ITEM: 6.1	COMMITTEE OF ADJUSTMENT REPORT SUMMARY MINOR VARIANCE APPLICATION FILE NUMBER A018/23 15 LADY BIANCA COURT, MAPLE
-----------	--

**COMMITTEE OF ADJUSTMENT REPORT
MINOR VARIANCE APPLICATION
A018/23
15 LADY BIANCA COURT, MAPLE**

ITEM NUMBER: 6.1	CITY WARD #: 4
APPLICANT:	Kevin Kliaman
AGENT:	Anna Boyko and Alexei Sitenko
PROPERTY:	15 Lady Bianca Court, Maple
ZONING DESIGNATION:	See below.
VAUGHAN OFFICIAL PLAN (2010) DESIGNATION:	Vaughan Official Plan 2010 ('VOP 2010'): "Low-Rise Residential" by Schedule 13 - Land Use and "Oak Ridges Moraine Settlement Area" by Schedule 4 – Oak Ridges Moraine Conservation Plan & Greenbelt Plan Areas
RELATED DEVELOPMENT APPLICATIONS:	None
PURPOSE OF APPLICATION:	Relief from the Zoning By-law is being requested to permit a swimming pool, uncovered platform (deck), including access stairs, hot tub roof structure and prefabricated sauna.

SITE PLAN

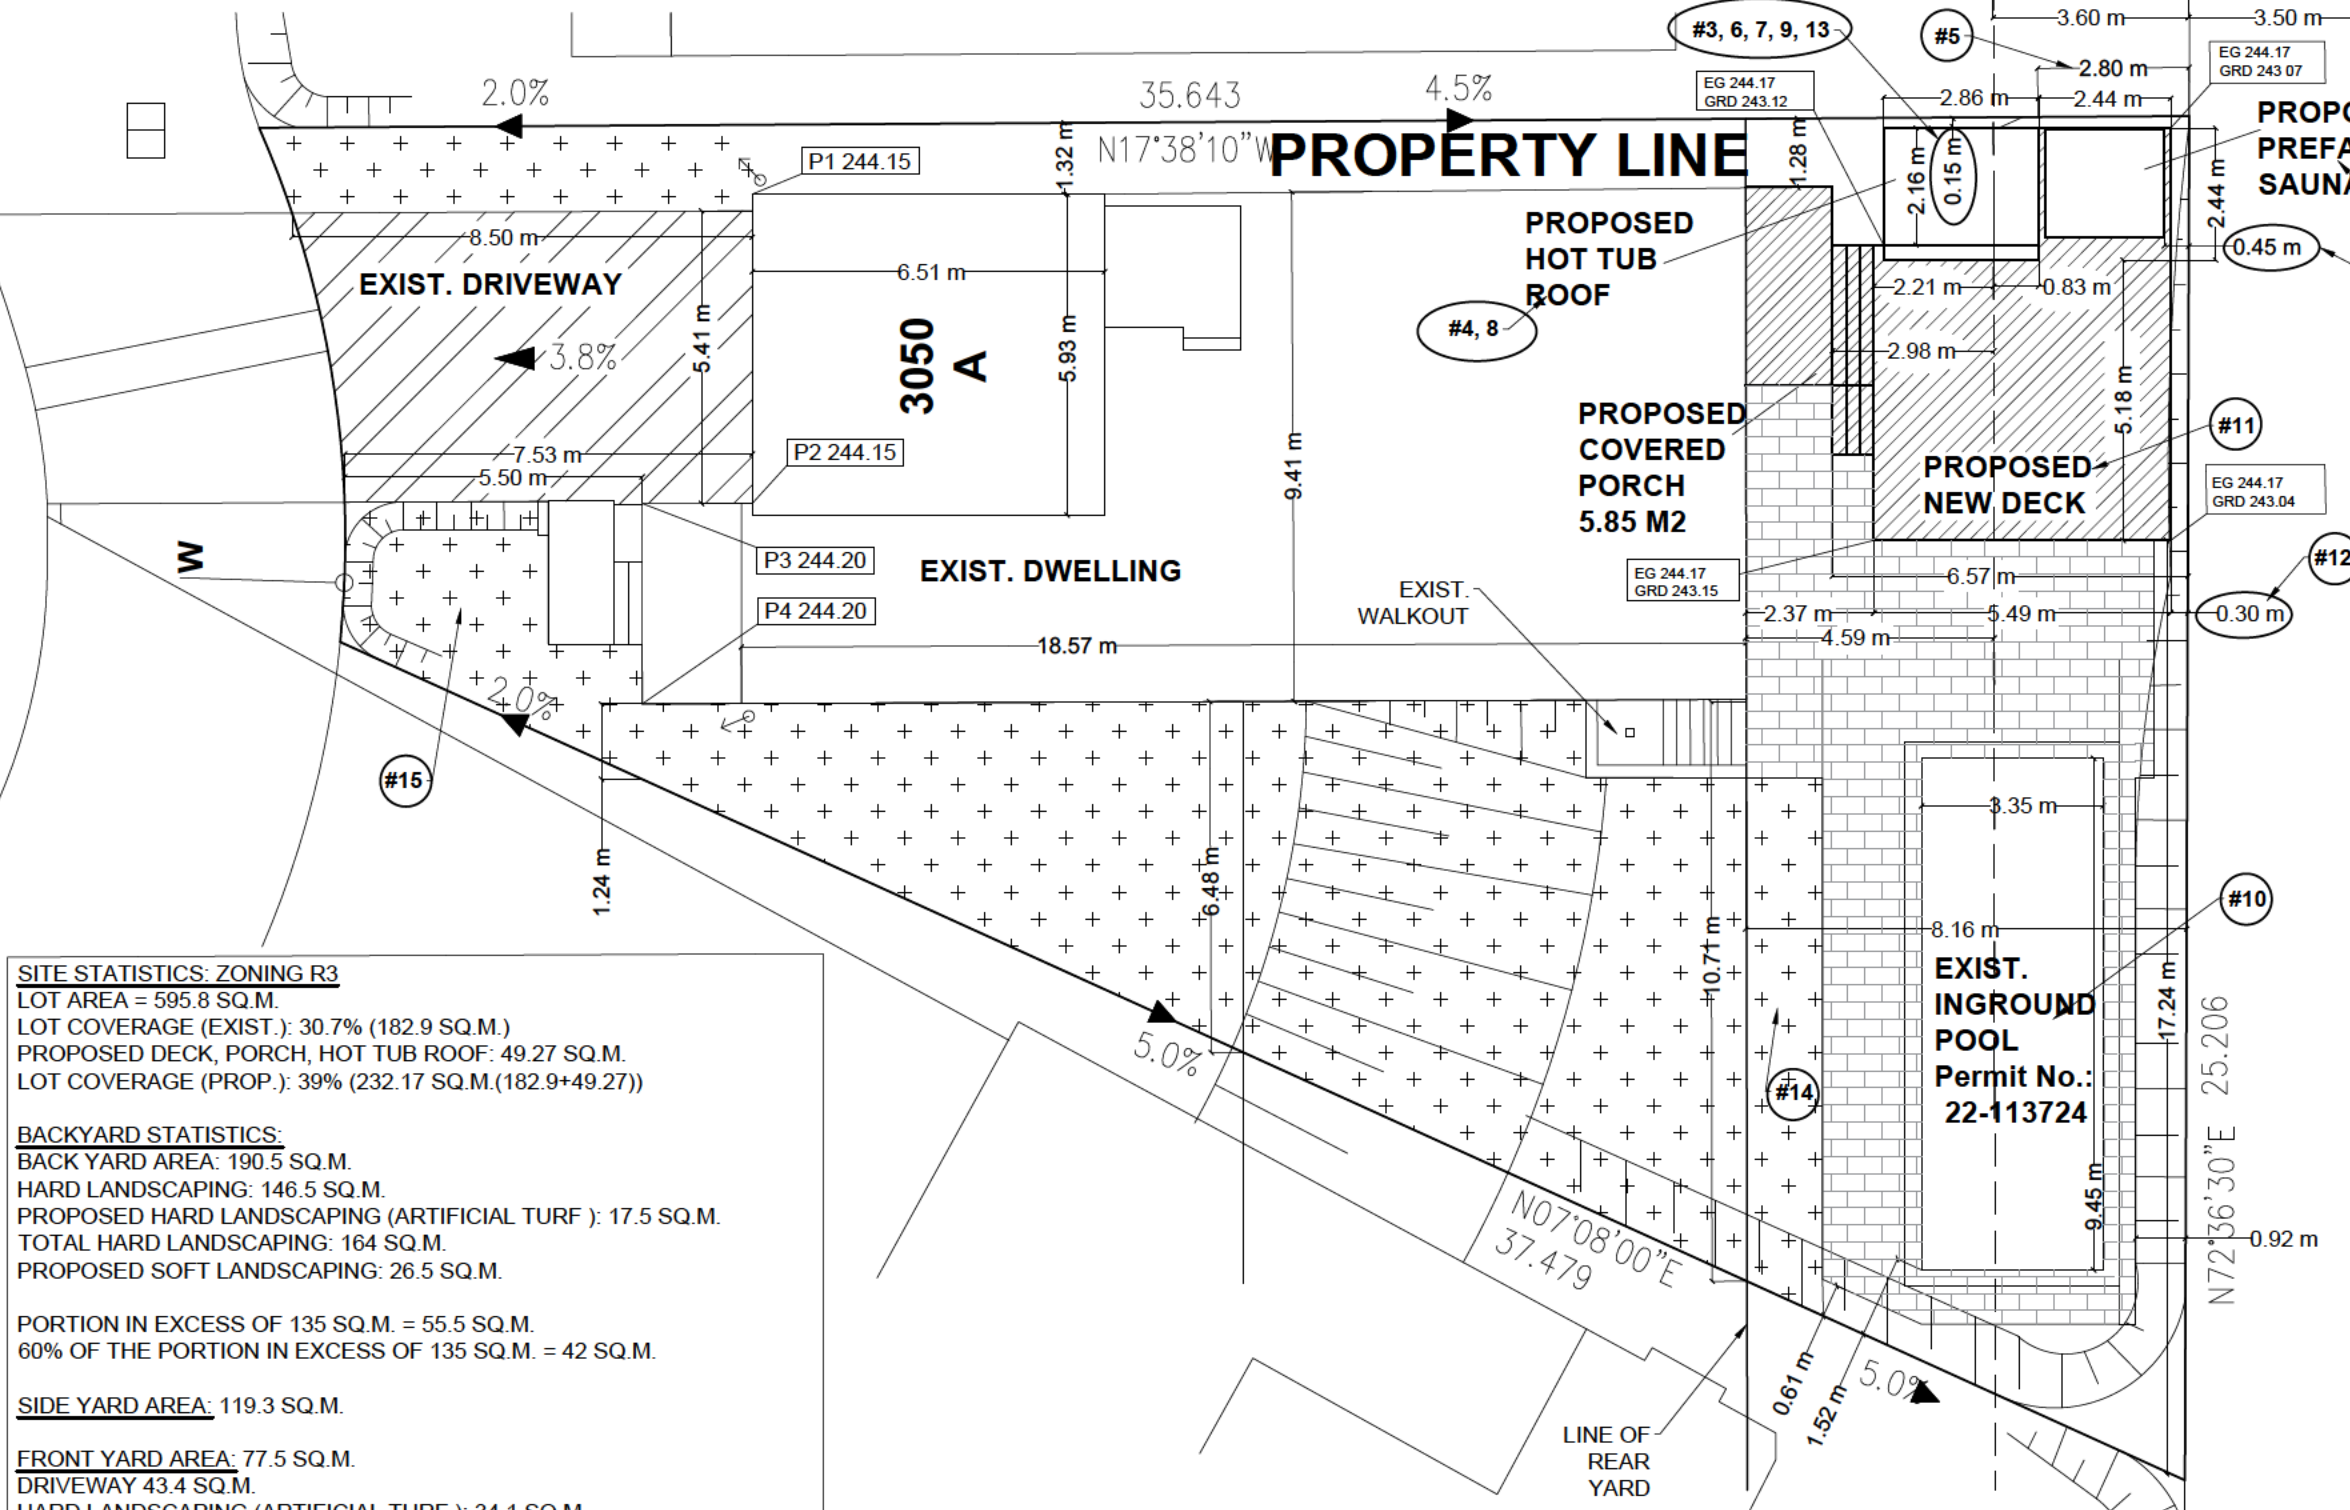
As per the submitted Site Plan, 0% soft landscaping for the portion of the rear yard in excess of 135.0 m² has been identified as well as 0% soft landscaping for the front yard. In an R3 Zone, any portion of the rear yard in excess of 135.0 m² shall be comprised of a minimum 60% soft landscape. The soft landscaping requirement for the front yard is also 60%. Development Planning typically aims to support reductions of soft landscaping of at least 50% for the portion of the rear yard in excess of 135.0 m² where circumstances to achieve full compliance are challenging. In terms of the front yard, Development Planning would like to see compliance with the requirements for soft landscaping. An increase in soft landscaping would help balance the softscape and hardscape features and remain compatible with other properties in the area.

The Development Planning Department is not in a position to support a reduction in soft landscaping, resulting in 0% soft landscaping for both the front and rear yard. I kindly ask that you please consider increasing the front yard soft landscaping to comply with the zoning provisions under By-law 001-2021 and increasing the rear yard soft landscaping to at least 50%.

On October 27, 2023, the Applicant submitted a revised site plan indicating all areas of soft landscaping, as requested by Development Planning and Zoning.

SITE PLAN

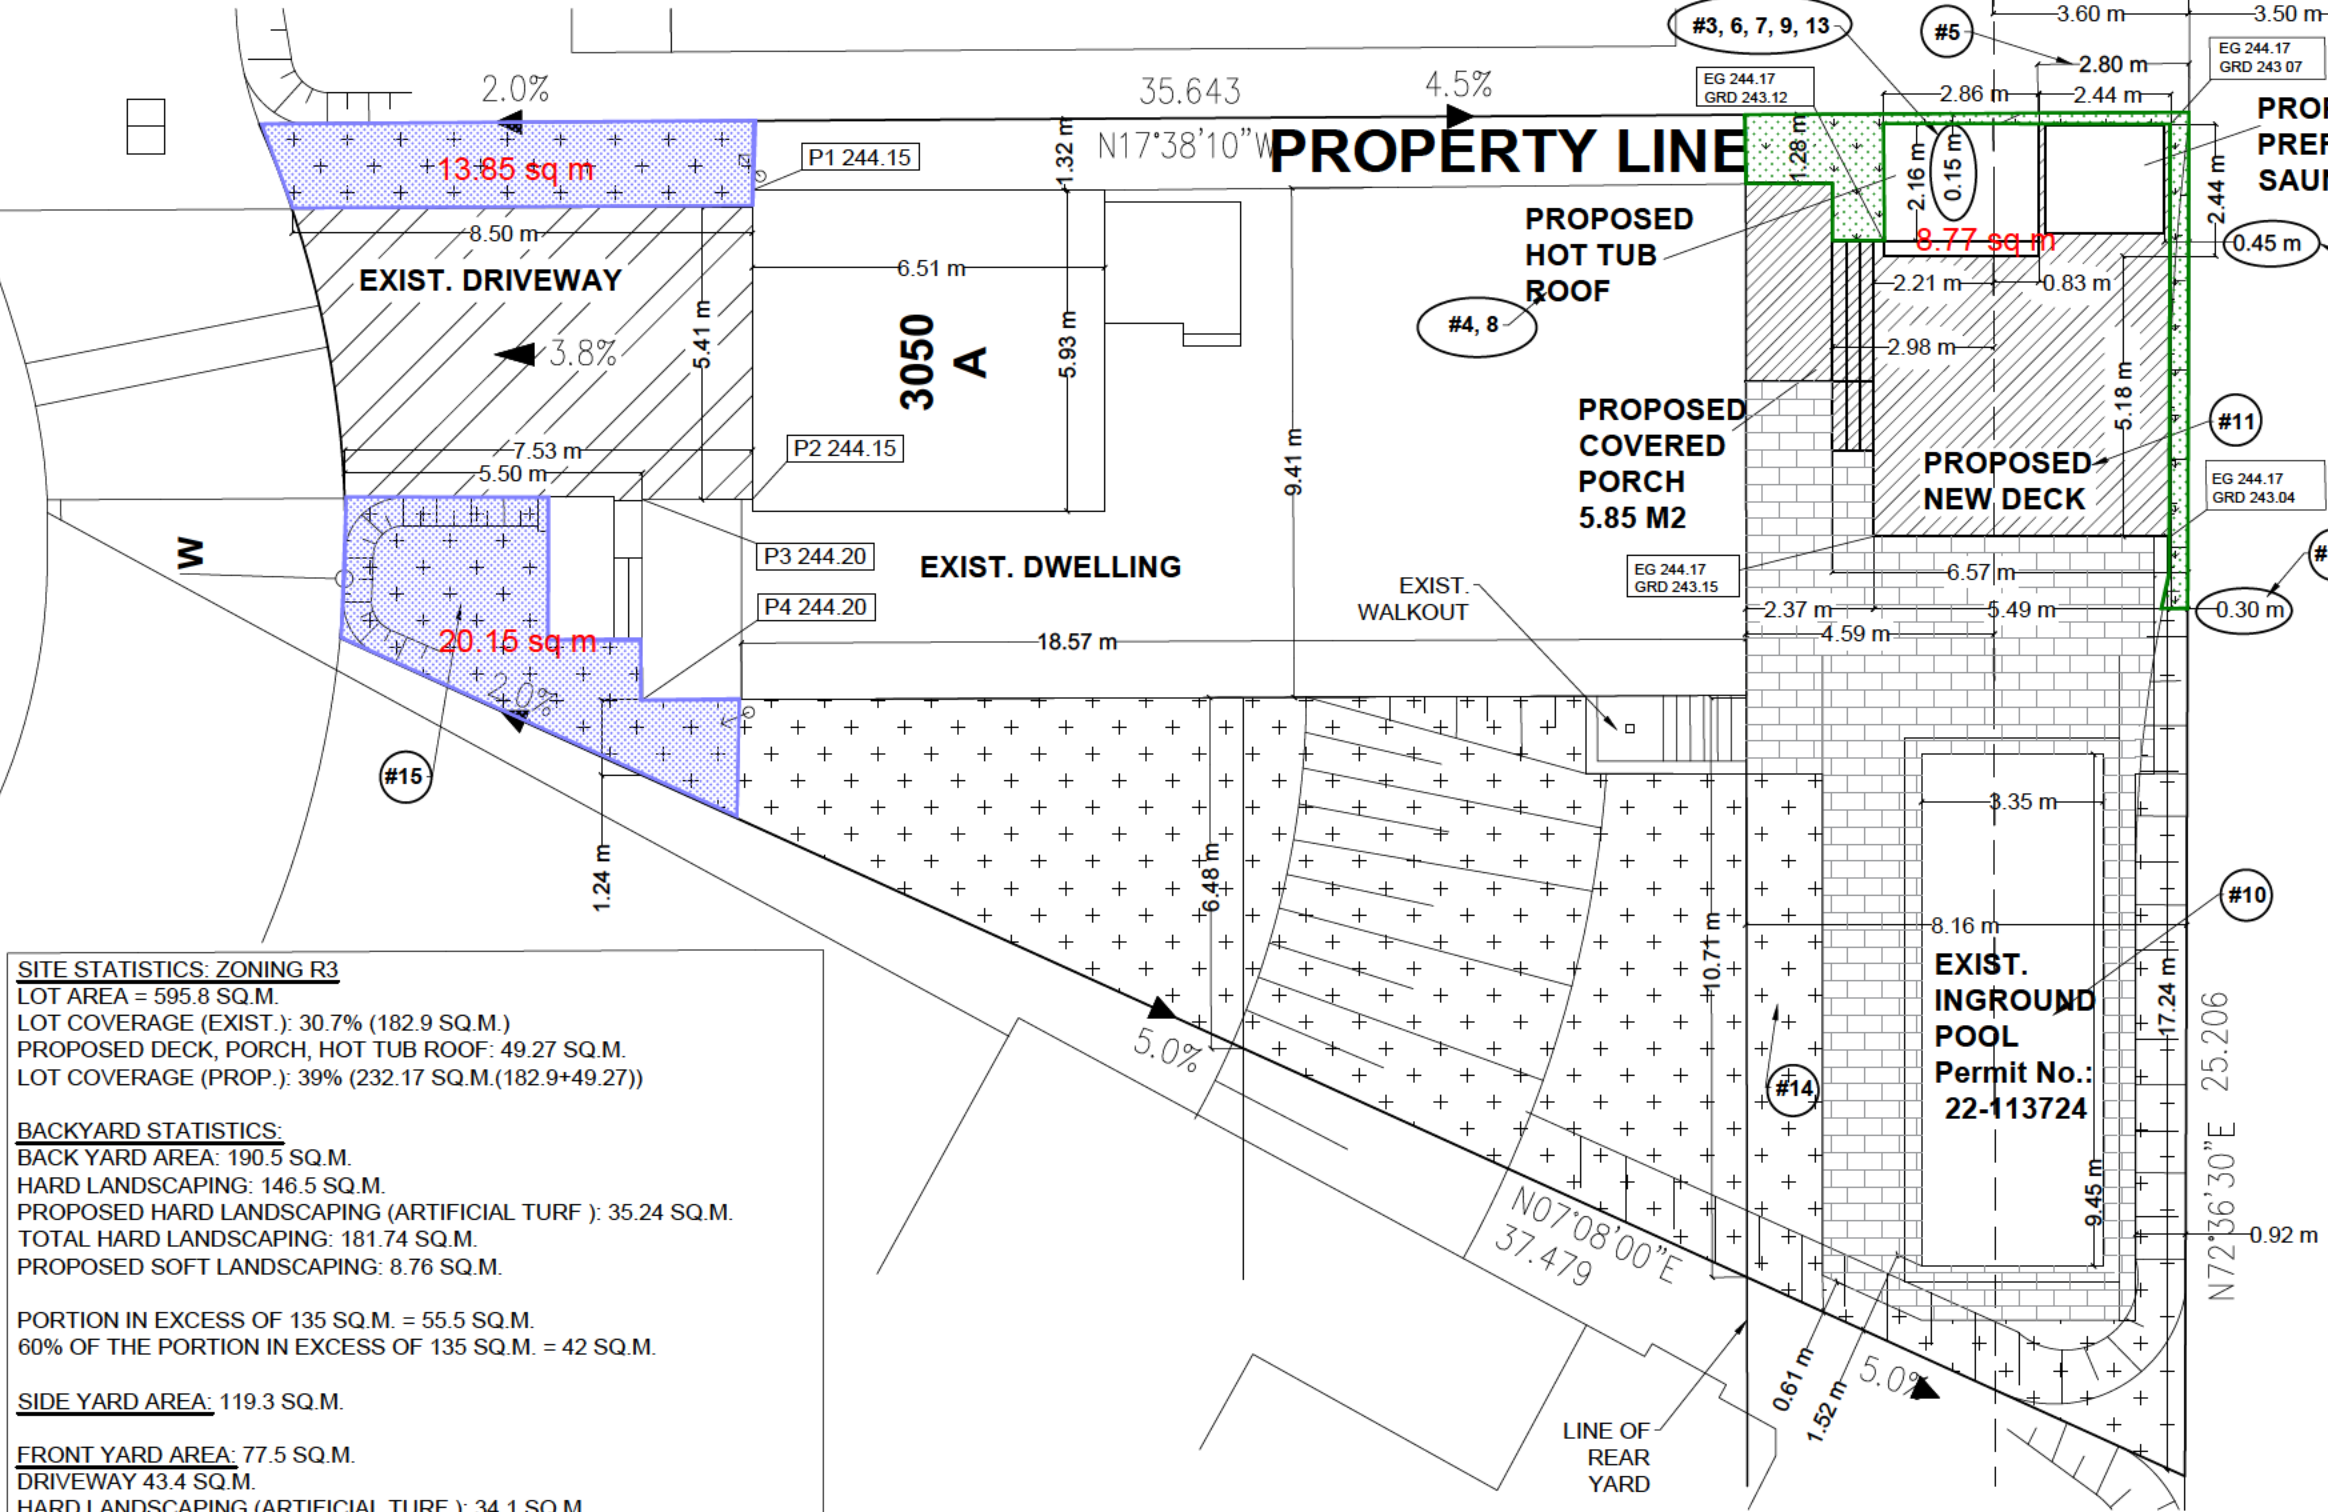
Upon conducting my site visit, I have observed turf located around the pool. Please see attached images. I kindly ask that the attached site plan be updated to accurately reflect the soft landscaping in the rear yard. Once this is done, Zoning can update the variance if necessary.

Please note that the Development Planning Department is not in a position to support a reduction in soft landscaping, resulting in 0% soft landscaping for both the front and rear yard. I kindly ask that you please consider increasing the front yard soft landscaping to comply with the zoning provisions under By-law 001-2021 and increasing the rear yard soft landscaping to at least 50%.

The Development Planning Department is not in a position to support Variances 14 and 15 for the reduced soft landscaping in the rear and front yards. The intent of the Zoning By-law is to limit the amount of hardscaping on residential lots to maintain a balance between hardscaping and soft landscaping. Some of the functions of maintaining sufficient soft landscaped area include: providing sufficient space for snow storage and stormwater attenuation/infiltration, providing space for the establishment of trees, noise attenuation through introduction of soft surfaces, and mitigating urban heat island effects. The proposed 0% soft landscaping for the front yard and 15.8% for the portion of the rear yard in excess of 135 m², are major reductions, and do not meet the intent of the soft landscaping provisions, and are not consistent with other yards in the neighbourhood. The proposed reduction also does not conform with Section 27(3)(b) of the *Oak Ridges Moraine Conservation Plan*, which encourages approval authorities to keep impervious surfaces to a minimum.
